Figure 2.12o
Infrastructure Design Review
- Turbine 15

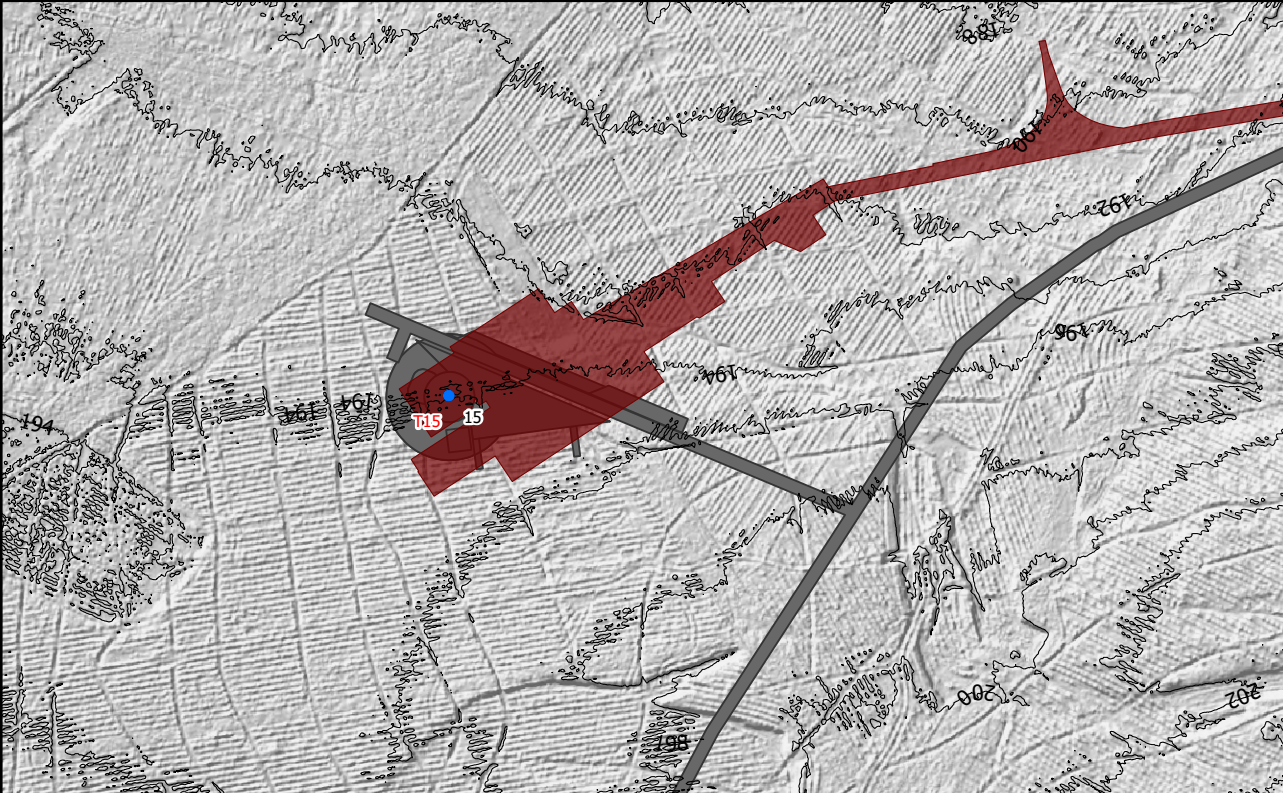
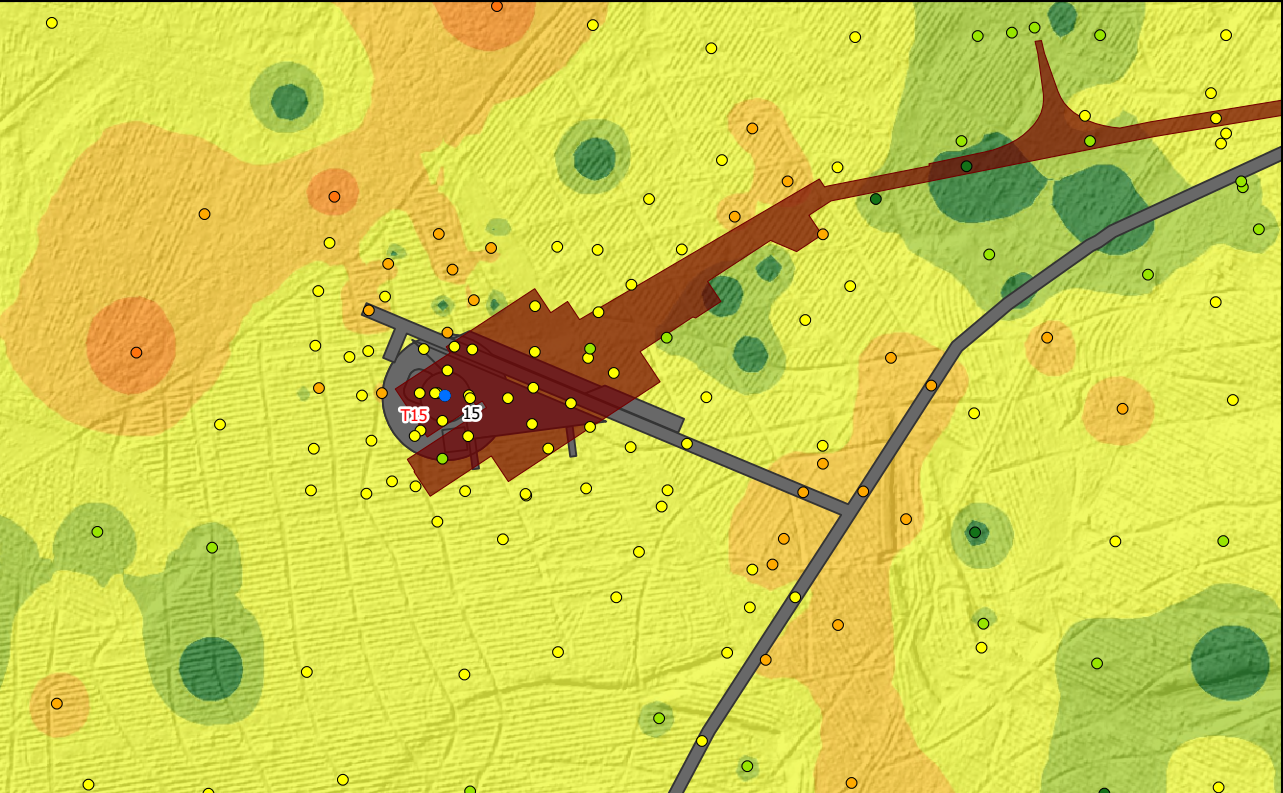
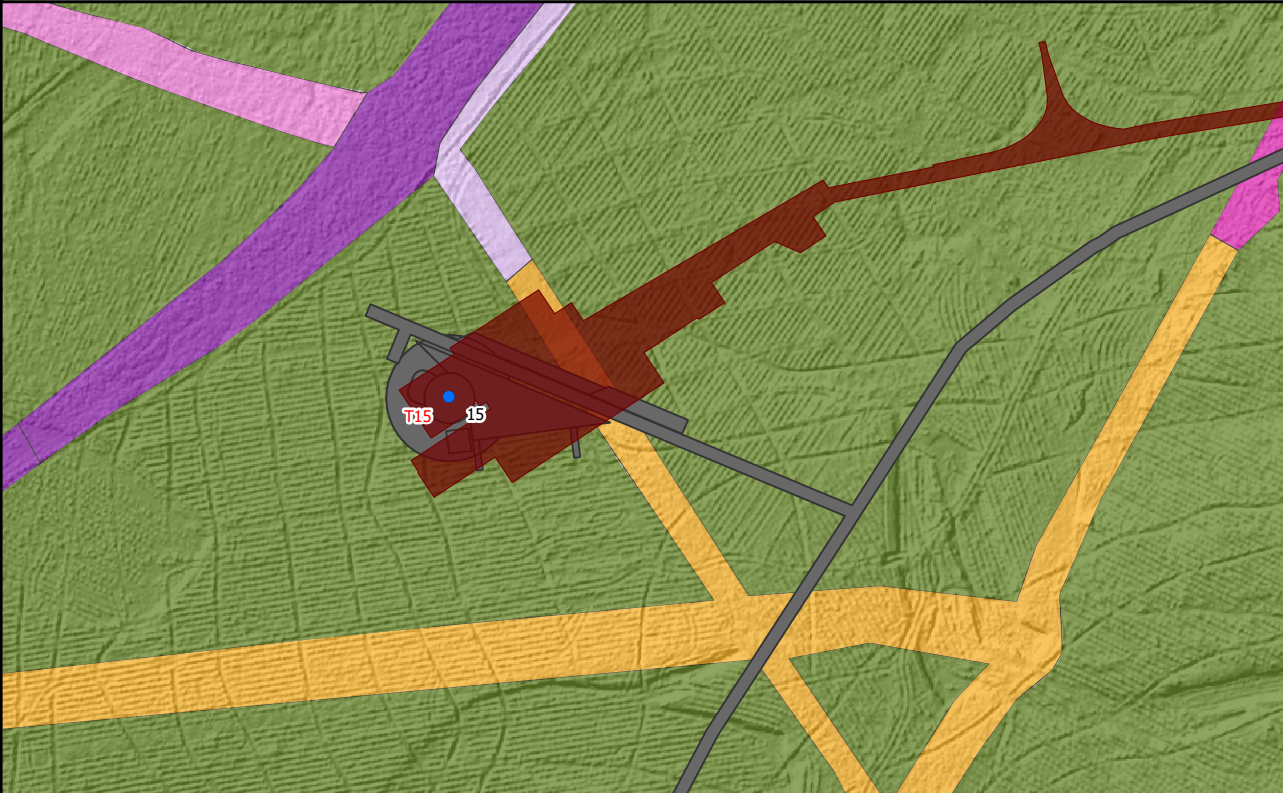
T15: Reason for Moving: This turbine location has not moved from the current consented location

Engineering: The hardstanding for the proposed layout is larger than the current consented layout. Due to this it is not possible for it to meet the track as shown in the consent. The hardstand has been rotated and the track as been realigned as required. A length of track approximately 500m long has been removed from the consented layout. This track linked T14 with the turbines to the south. Due to this reduction in track length a turning head has been introduced to allow delivery vehicles to exit the site. The plan for turbine deliveries is to drive directly onto the hardstand and offload components. The unloaded vehicles will then use the turning head between T15 and T16 to turn and exit the site.

Geology Impacts: Due to maintaining the consented position of this turbine and the introduction of the larger hardstand, there was a negative impact on the peat. This has been mitigated by flipping the hardstand and having the hardstand in a nonstandard configuration. This will require additional time and non standard lifting for the turbine deliveries, however it reduces the need to construct in the deep areas of peat to the West of the location.

Ecology Impacts: The turbine and infrastructure is located in an area that was commercial coniferous forest. The trees have now been felled. Landowner (FLS) has begun peat restoration in this area.

Hydrology Impacts: There are no water buffers within the area adjacent to the turbine location.
